Technical Document 105

AN/PRC-56 HELMET RADIO SET UPGRADING

Field Change (1)—AN/PRC-56 Radio Set
Operational and Reliability Improvements; Type II, Class A
Routine Action: 1.5 Man-hours/Radio

APPENDIX B: ECPs ASSOCIATED WITH RECOMMENDED FIELD CHANGE

Figure 2. The old and new push-to-talk switches. Notice that the new switch is relocated and that the switchguard has been removed. The hole resulting from the switch relocation has been filled with epoxy.

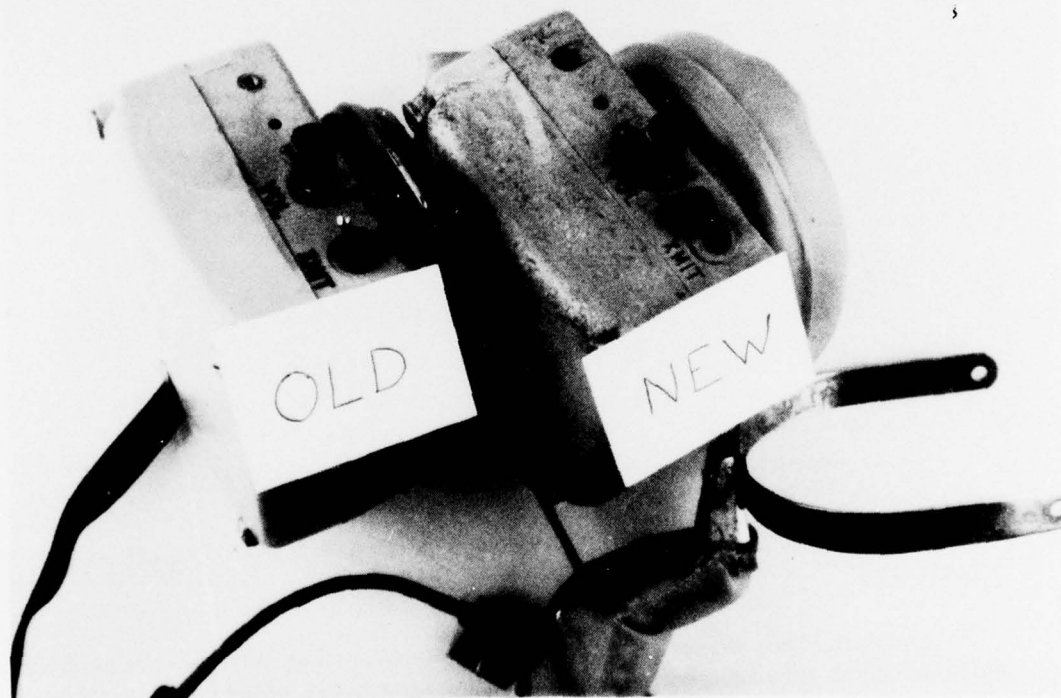
the normally open contacts. The best mechanical solution to the push-to-talk switch problem is to replace the existing toggle switch with a pushbutton switch. Miniature pushbutton switches with the rugged characteristics needed are readily available; two MIL-SPEC types were identified – M8805/64 and M8805/96. Both the M8805 switches are spst rather than spdt; however, this is a reconcilable difficulty. Also, although there is space for the switches, the mounting hole must be relocated slightly to fit them into the case. To resolve the spst/spdt difference, the receiver section was wired on, bypassing the push-to-talk switch, and worst-case tests (transmitter and receiver on the same frequency) were conducted to measure circuit stresses and to ensure no reliability problems would be introduced. This same fix was suggested independently as a solution to the problem of lack of sidetone (problem 11), since it allows the speaker to hear himself through the base station retransmission. Both the M8805 styles are satisfactory in fit and function. The M8805/96 has a more positive action and requires less force to operate, but the M8805/64 has a shorter plunger travel, which is compatible with a M5473/10-01 boot seal. Also, the M8805/64 is somewhat less expensive and easier to install; therefore, it is recommended as the replacement push-to-talk switch (fig 2).

17. Install the pushbutton switch M8805/64 with the M5423/10-01 boot. Solder the blue and white wire (from terminal 4 of TB1) to the bottom terminal of the switch. Solder the two wires which were lightly twisted together in step 4 (brown and white from E6 on the receiver; green and white from terminal S of TB1) to the top terminal of the switch. Note that the receiver will now remain on when the push-to-talk switch is activated.

Figure 3. The old and new on/off switches. Notice also the alternate foam-filled ear cushion.

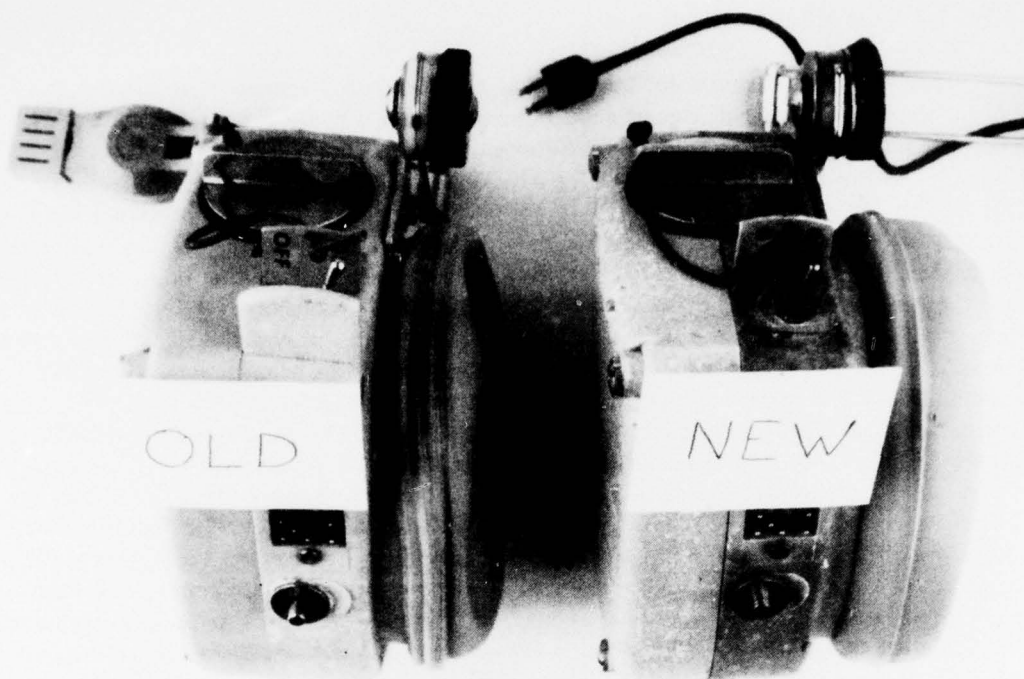
The on/off switch (fig 3) presents a different problem. The switch should provide a visual indication of its position in addition to being more rugged and dependable. Three types of switch were considered – toggle, slide, and rotary. No slide switches were found which

Of these alternatives, the ALCO switch requires the least case modification; but while this switch is mechanically more rugged, its electrical contacts are only slightly more reliable than those of the existing switch. The CSI switch and the MIL-SPEC switches are all significantly more reliable and dependable than either the ALCO or the current switches; however, they are all sufficiently long to be subject to interference from the RFI filter board in the transmitter pod. If any of these latter three switches are used, the RFI filter assembly should be moved approximately 1/8 inch (3 mm) up in the pod. The other case modifications to the PRC-56 involve removing a block of excess plastic from the inside of the case next to the mounting hole and removing the outer switchguard. The MS24655-241 is the recommended replacement.

8. Install the toggle switch (MS 24655-241) with the terminals toward the outside of the pod (away from the ear defender side), using the switch boot from the old switch. It will probably be necessary to file the plastic block in the corner of the pod back to make space for the switch; a sharp knife will assist in cutting away excess material. The "on" position of the switch should correspond to the "on" mark on the inside switch protection tab. Solder the wires removed from the old switch to the new switch; the wire from the battery (red and white) should be connected to the top terminal.

Figure 4. The old and new microphones, boom assemblies, and connecting cords. The new boom assembly has a longer foreboom. The connecting cord is wrapped around the boom to avoid snagging and to provide strain relief.

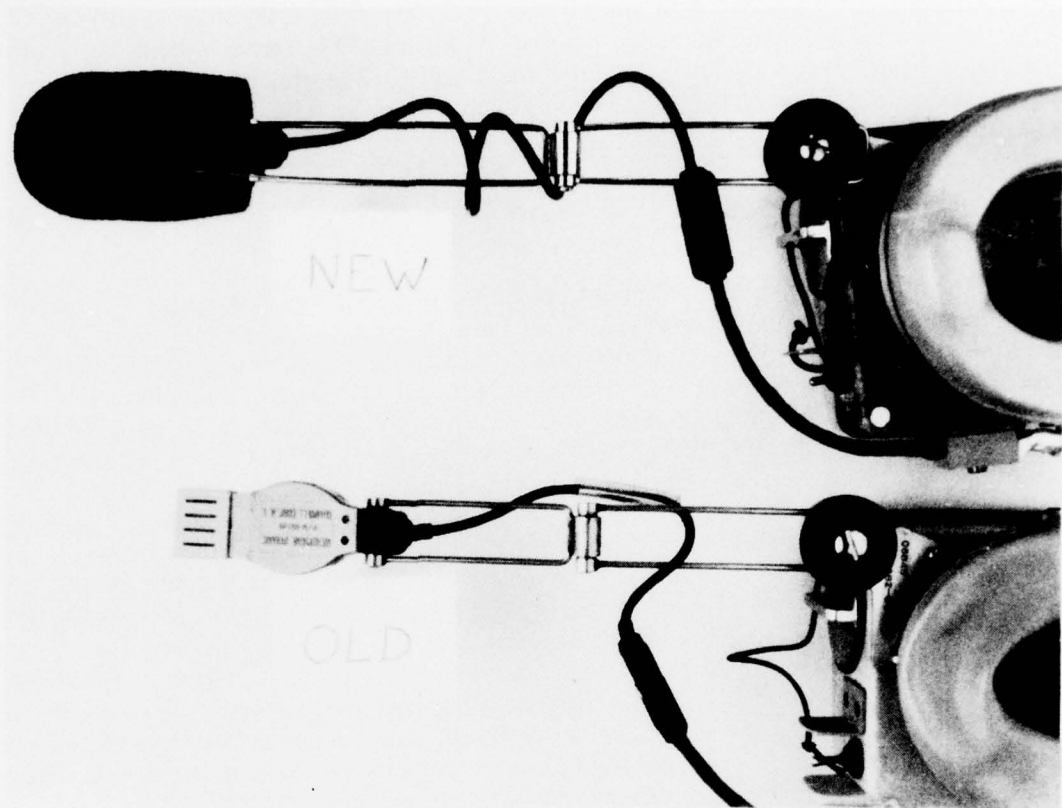
The M-87 microphone, microphone cord, and mike boom collectively suffer a very high failure rate. Failures in the microphone are both electrical and mechanical. The electrical failures appear to be caused by humidity admitted through either cracks in the case or leaks around the element seal. The cracks in the case are simply incomplete mechanical failures. A leaky element seal is most probably caused by the tearing or loosening of the seal by wind pressure. In fact, the M-87 is susceptible to saturation by wind; in the saturated condition, the output drops by at least 50 percent and the noise-canceling characteristic virtually disappears (problem 2). Another possible type of electrical failure derives from shorts or insulation breakdown, or, in conjunction with other failures, welding of the dynamic windings due to intense electromagnetic fields encountered on the flight deck (up to 200 V/m); however, there are no data confirming or refuting these failure modes. In any case, the primary electrical failure mode is humidity entering through a leaky element seal. The mechanical failures are mostly cracked cases resulting from rough abuse. The mike boom is a two-piece wire loop assembly. The most frequent failures occur at a weld on the hinge between the two pieces or at one of the wire loops. Virtually all the documented failures resulted from users' attempting to bend the mike boom to place the microphone closer to the mouth. The foreboom (the loop connecting to the microphone) is not long enough to fit all users comfortably (see fig 4). The failures to the microphone cord were breaks in the wires at the connectors (usually at the microphone end), primarily in the cloth-covered versions (as opposed to rubber or plastic coated). There are some false replacements of the microphone and cord due to input transformer failures, but these probably constitute about 12 percent of the total replacements. Research revealed a microphone assembly in the National Stock System which is made up of the M-87 with a windscreen, a mike boom with a longer foreboom, and a rubber coated cord; the stock number is 5965-00-181-0213. The windscreen will protect the M-87 from wind saturation, the element seal from wind tearing, and the case from much of the normal abuse. Additionally, the windscreen reduces annoying speech artifacts from "p" and "s" sounds and helps the user to properly position the microphone for maximum output and intelligibility.

9. Remove the microphone M-87, microphone cable (W3002), and mike boom by removing the bolt holding the boom swivel to the mounting plate.
10. Install the microphone with windscreen, boom, and cord assembly (item 1). Wrap the cord assembly around the boom 2½ times before plugging it into W3001.

Figure 5. Application of adhesive sealant.

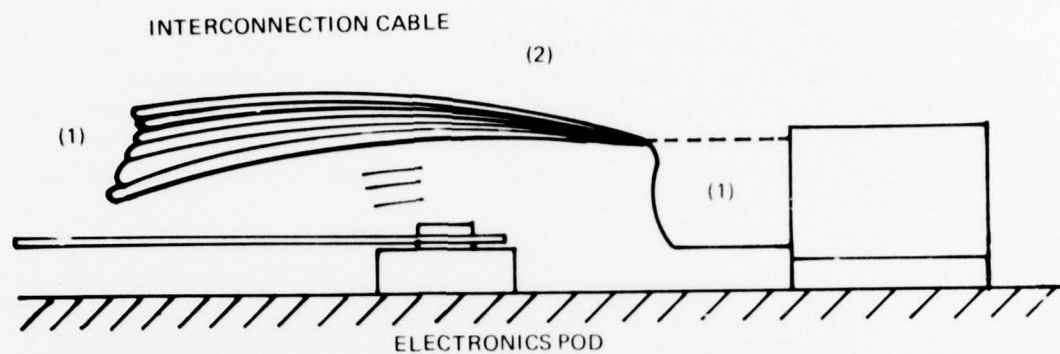
- (1) FILL WITH RTV-102 (ADHESIVE SEALANT); DRY 24 HOURS (MIN) [1 WEEK PREFERRED]
 (2) COAT WITH RTV-102 FOR ABOUT 1 INCH (25mm) LENGTH INCLUDING PART OF THE CABLE TWIST

Figure 6. RTV-102 applied to a connecting cable to provide strain relief. Notice how the cable is held away from the pivot on the earpod.

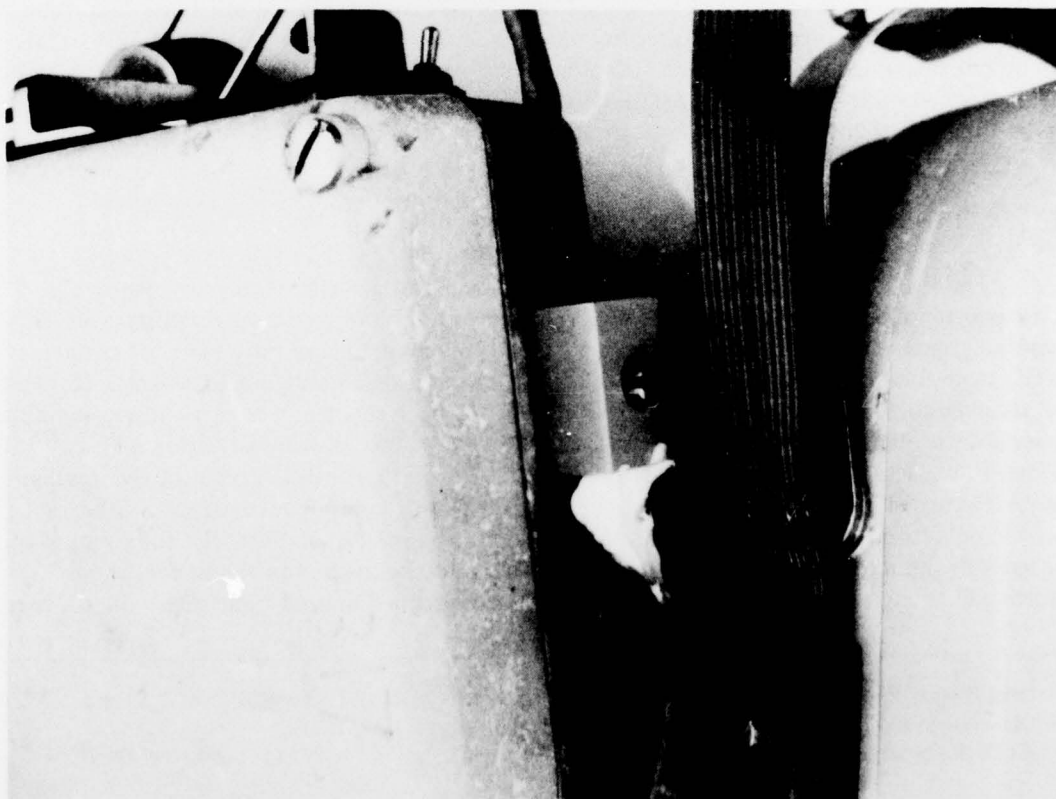
The cable assembly between the electronics pods has a moderately high failure rate. Many of the failures occur in the ribbon cable where it enters the connector blocks. At this point, the cable is flexed across its width rather than in line; this puts a severe fatiguing strain on the cable. In order to relieve the strain, it is recommended that adhesive sealant RTV-102 be applied in accordance with figure 5 or 6. Although other failures occur within the connector blocks, the design precludes doing anything to correct this problem.

23. Lay the radio so that W3001 is on top and form the cable near each connector so that the cable is above the top of the connector and forms a 1/4 inch gap between the cable loop and the connector.

24. Ensure that the cable and connector are clean and dry. Apply RTV-102 to fill the gap between the cable and connector in accordance with the directions on the tube. Allow to cure at least 24 hours.
25. Reinstall the radio in the helmet assembly.

Figure 8. Tape wrapped tightly around the core of a variable inductor keeps the core from vibrating out of adjustment.

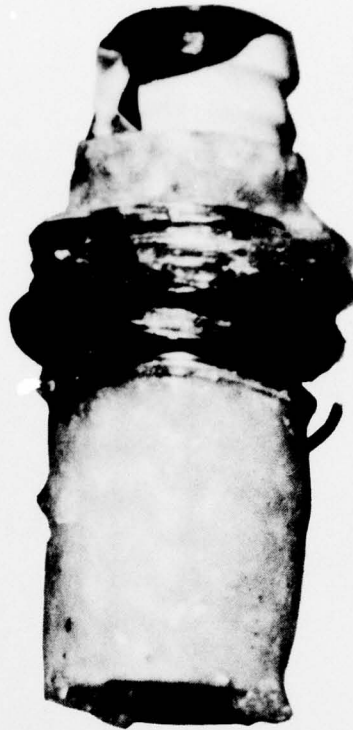
The PRC-56 is very susceptible to impact shocks and acoustic vibrations, especially in transmitter and receiver alignments. Fully 20 percent of all reported total failures (ref 4) are misalignments only and do not require a part replacement. Temporary losses of signal in certain deck locations also result from misalignments. Transmitter alignment requires 18 steps and receiver alignment requires 48 (ref 5). Considering both setting up to test and reassembling the radio, the alignment procedures require skilled maintenance manpower (often a Petty Officer First Class). A few of the adjustments are somewhat critical, but most of the misalignments are caused by the mechanical instability of the tuning components, especially the variable inductors. It is recommended that Teflon tape be used to stabilize the tuning slugs of the variable inductors. The tape will allow adjustments to be made, but the impact shock effects will become minimal. Figure 8 illustrates tape wrapped around a variable inductor core.

- a). Remove the tuning slug (count the turns required to back out the tuning slug to expedite returning).
- b). Cut a strip of Teflon tape 1/8 inch wide by the width of the tape.
- c). Wrap the tape tightly onto the tuning slug in a spiral in the same direction as the threads. Do not wrap the tape over itself. The tape should be stretched to conform to the slug.
- d). Replace the tuning slug.

Figure 9. MX-2507/AIC pads installed to relieve pressure.

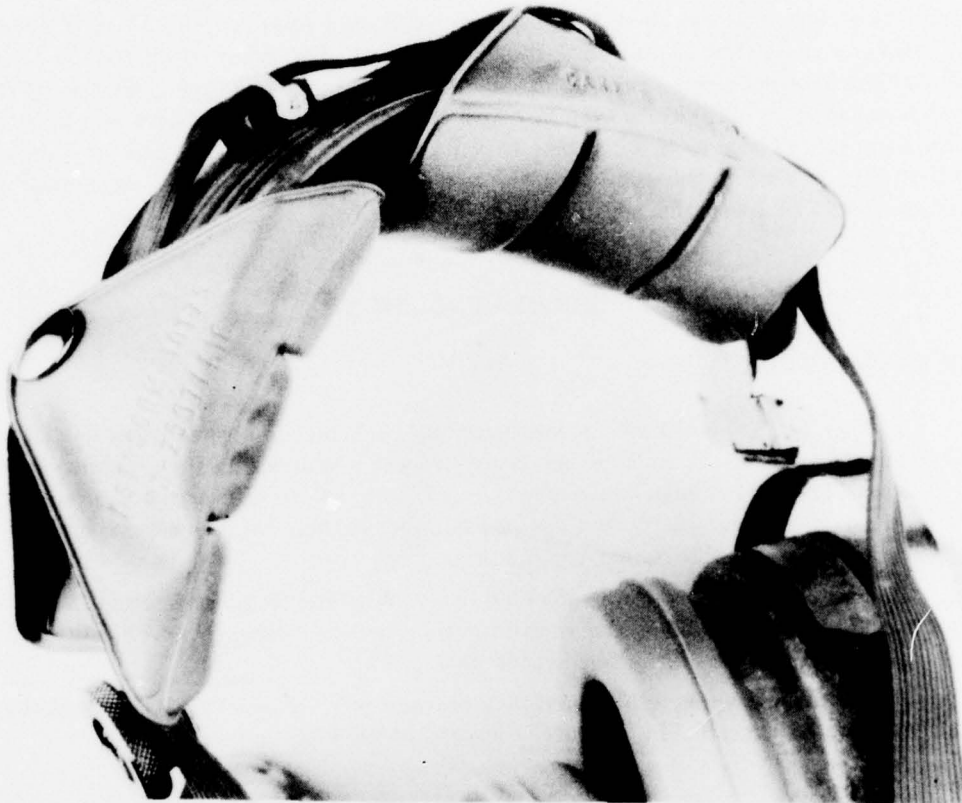
Most irritating is the presence of severe pressure points on the top and sides of the head resulting from the concentration of the entire weight of the transceiver onto the headband pad and the sagging of the electronics pods into the neck. The weight can be redistributed by snapping two headband pads from the H-157/AIC over the ends of the headband as shown in figure 9. These pads will distribute the weight sufficiently so that most users will not suffer excessive pressures. The pads are designated MX-2507/AIC and are available through the stock system under NSN 5965-00-715-6162 (less than \$0.90 each).
